CREDAI - MCHI

Ref: No. MCHI/PRES/22-23/345
Date: 16/11/2022

Subject: Revisiting the NOCAS calculation on account of the introduction of the buffer of 5 Nautical miles applied around the sector of lower Minimum Sector Altitude by GSR 770 (E)

Figure 2: 5 NM buffer addition area

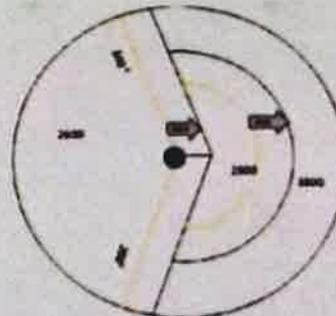
As per the said amendment, the lower sector area extends by 5 NM towards the higher sector as depicted below:

This buffer is used by the procedural designer as per the provisions of PANS-OPS for obstacle consideration:

- When aircraft transit from the higher to the lower sector, the descent is not given until it crosses the higher sector.
- When an aircraft transit from a lower to a higher sector, it maintains the altitude of the higher sector into which it enters.

Therefore, in both cases, the aircraft is not maintaining a lower sector altitude in the buffer area of 5 NM. Ideally, it should be maintaining the lower sector altitude by obstacle consideration. Nevertheless, AAI would be in a better position in understanding the subject and issue.

For ARSR

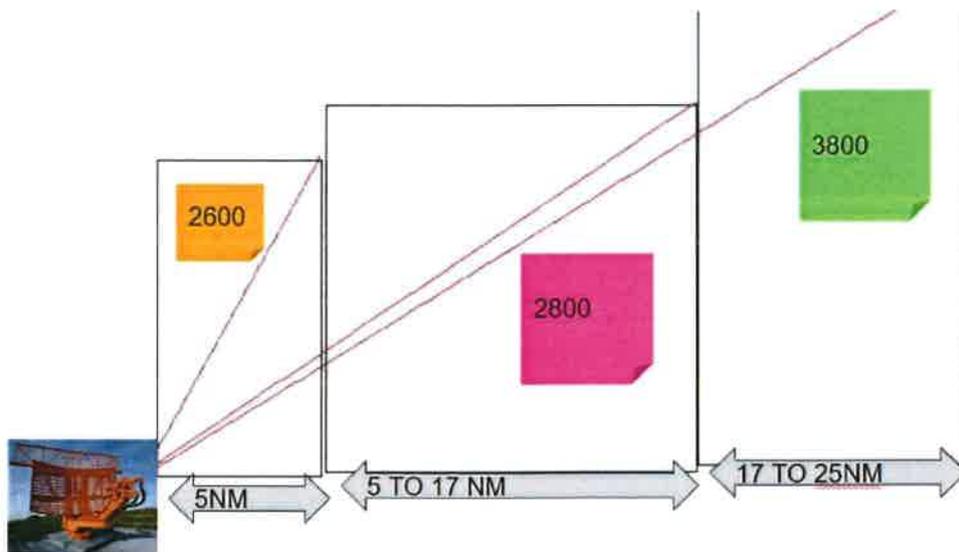
Now, with the implementation of Rules 2020 - GSR770(E), we find the calculation change and the lower altitude MSA calculated angle is applied for even the buffer area, different than the above principle.

As per our understating, as per GSR751 and GSR 770(E) with 5 NM protection rule, should be calculated as below

(Sector height for a specific distance may be calculated/considered and the least of the calculation may be applied for the issue of NOC height)

We, therefore, request your good office to revisit the calculation/interpretation of the above change or the NOCAS software to transform the above principle into a NOC result.
